# Planning Officer Report

268 – 274 City Road, Southbank

Planning Permit Application No. 201535464

**Figure 3: Proposed site in context with other towers in Southbank**

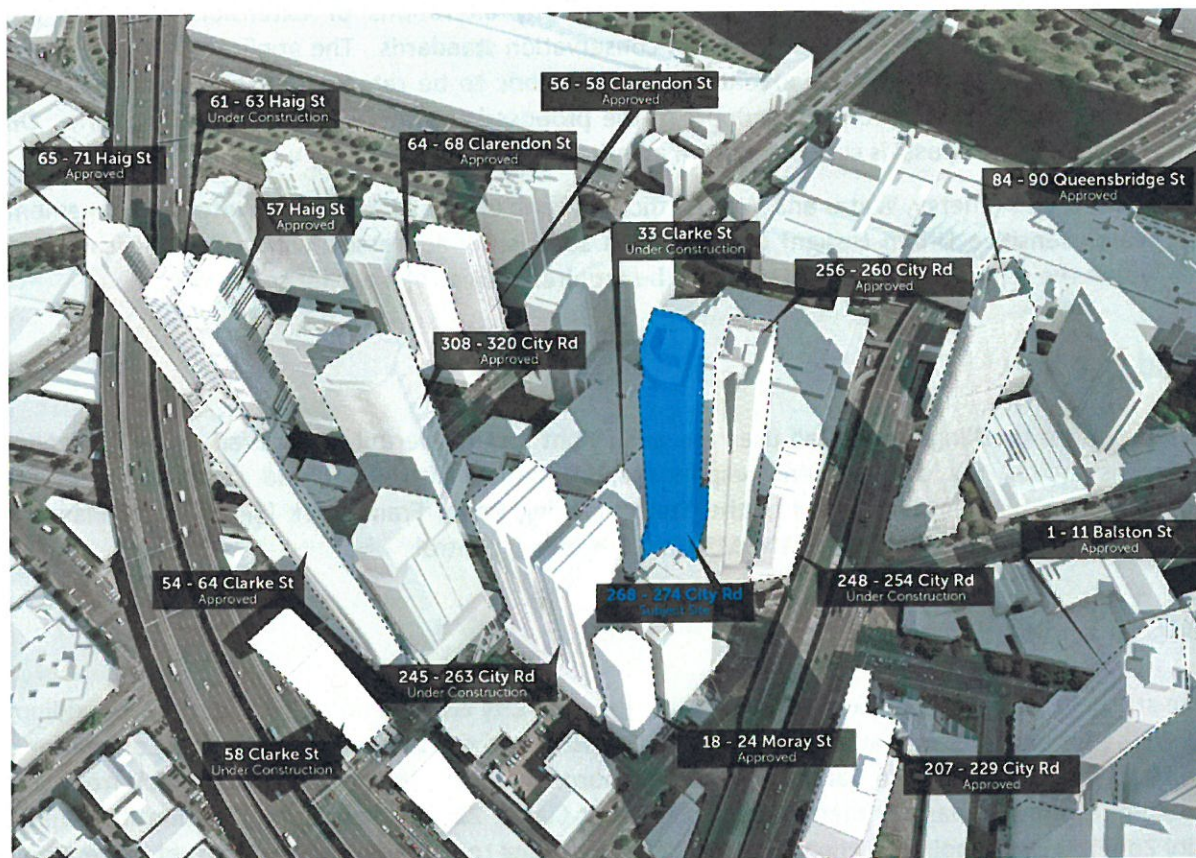
With regards to building height, a discretionary maximum height of 160 metres, with a podium height of 30 metres has been applied to the site under Area 2 of DDO60. The proposed building will have an overall height of 179 metres excluding the roof plant and lift overrun projecting above the tower. While this will exceed the discretionary height limit by approximately 20 metres, the proposed height responds appropriately to the context (see context figure below).

In particular the adjacent site the east has been approved at approximately 190 metres within the same DDO60 control; 256-260 City Road is an approved 61 storey tower with a 9 storey podium on a site of 1265m<sup>2</sup>.

**Figure 4: 'Original' Typical Floorplan:**

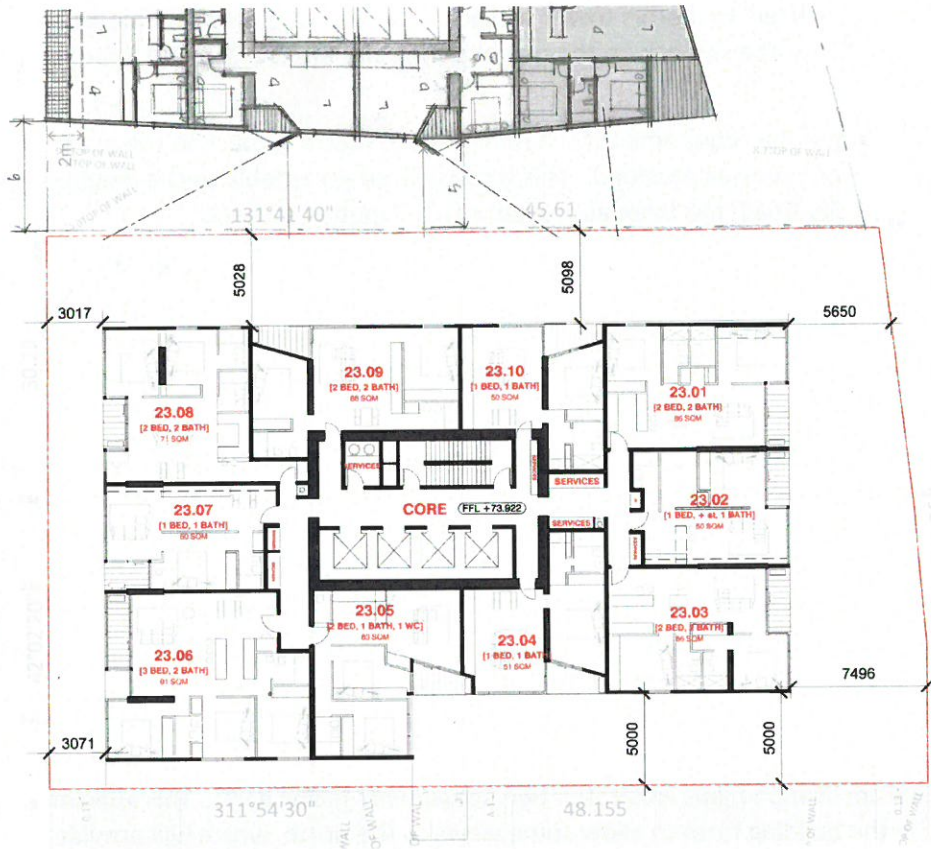
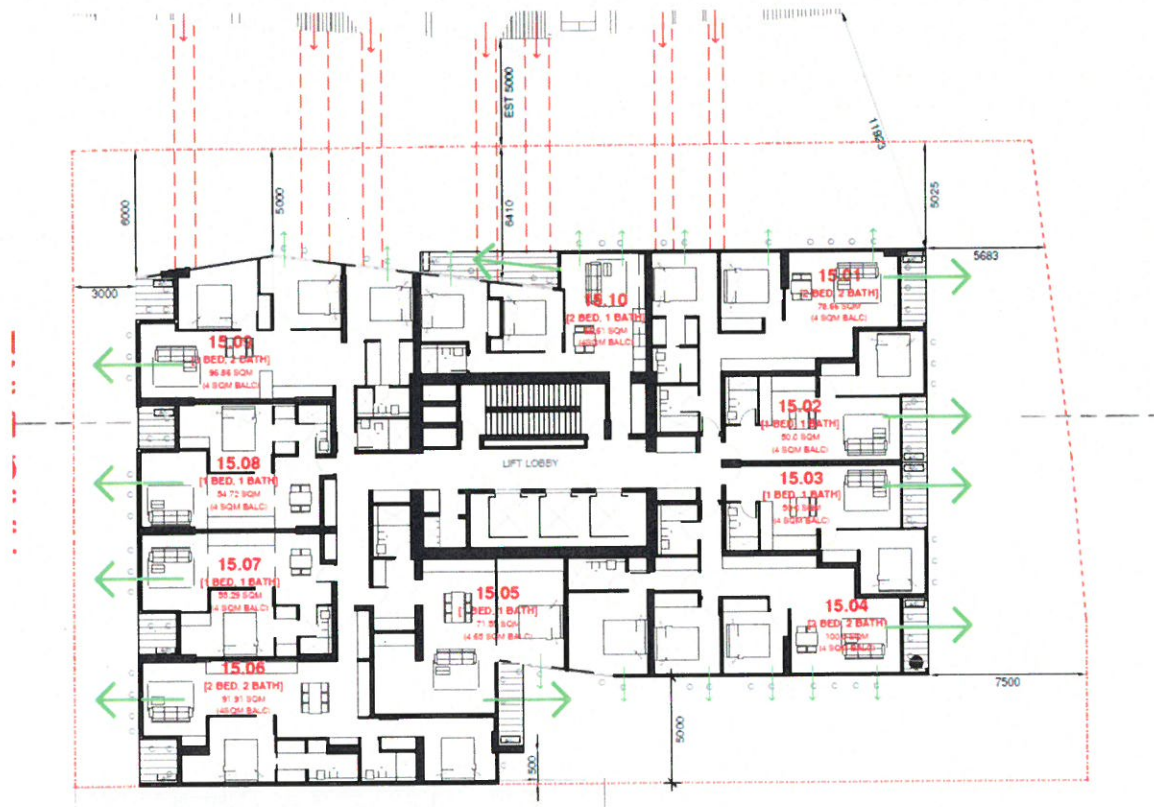
Amendments have also been made to the design to focus views from living rooms in a north or south direction. Again there is only one apartment centrally located (facing west) however there are views now afforded to the south. It was not considered necessary from a design or amenity perspective to increase the setbacks to the 33 Clarke Street site above level 47 or redesign the crown of the building (as suggested by the Melbourne City Council, Conditions 1a and 1b).

The revised plans submitted in October 2016 provide an improved amenity outcome for residents. The windows on the eastern side have been designed with alternate obscure and clear glazing to align with the various living spaces of the building at 256-260 City Road. The central apartment within the eastern side (typically apartment 10) is the only one with a living area not facing north or south (the original application plans illustrated two apartments facing east). This apartment benefits from a 'cut out' in the building form to allow some views to the north, which will provide adequate amenity (see Figures 3 and 4 below). The outlook from two apartments on level 9 (09.05 and 09.10) are blocked by structural elements and do not provide adequate amenity- a condition will be added to correct this situation.
